Ref.: Water Lane Outline Planning Application, 23/1007/OUT

ECS Response to Water Lane Outline Planning Application: 23/1007/OUT October 2023

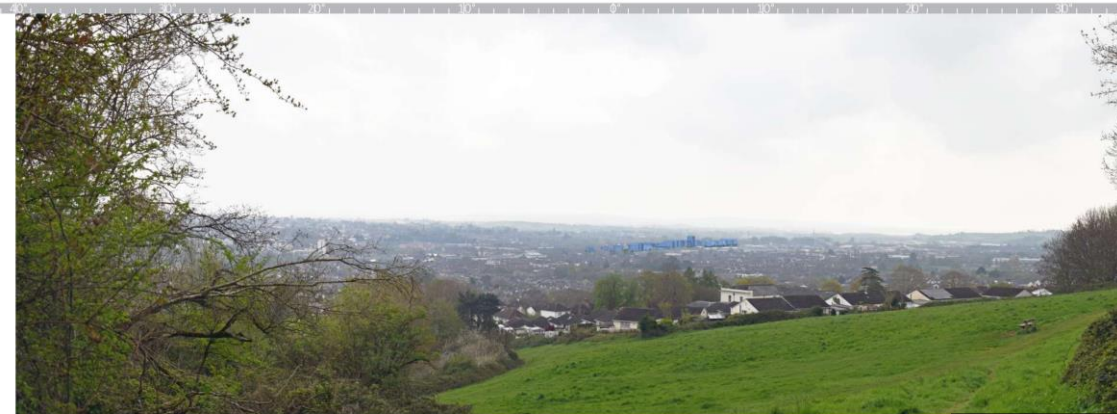
ECS approves the recommendation for a 'neighbourly scale' of the development, that is 'respectful to the existing residents around the edges of the application site' by offering 'a lower scale along these boundaries' (PD&AS 5.107). We do not think that proposals follow this suggestion: F1, G1 and H1 are outlined in the parameter plan as up to five storeys high (PD&AS, pp.136f.), with details presented in 'Illustrative Storey Heights' (pp. 88f.) showing

that the lower part of these buildings is not facing the existing buildings. We think an up to 4 storey height would be much more suitable for the existing housing being 2-4 storeys high. Whilst block F1 appears to be an appropriate height, block G1 with its gabled roof appears to be too high; maybe flats roofs would be better. The visualisation App B-23 demonstrates clearly the overbearing height of the Block G1, and blocks A1 to D1 from the river/canal direction.

For all of these reasons **ECS strongly objects to the currently proposed Building Heights Development Parameter Plan. A maximum building height of not more than 5-6 storeys (with sensibility towards already existing building's heights) must be made a planning condition.**
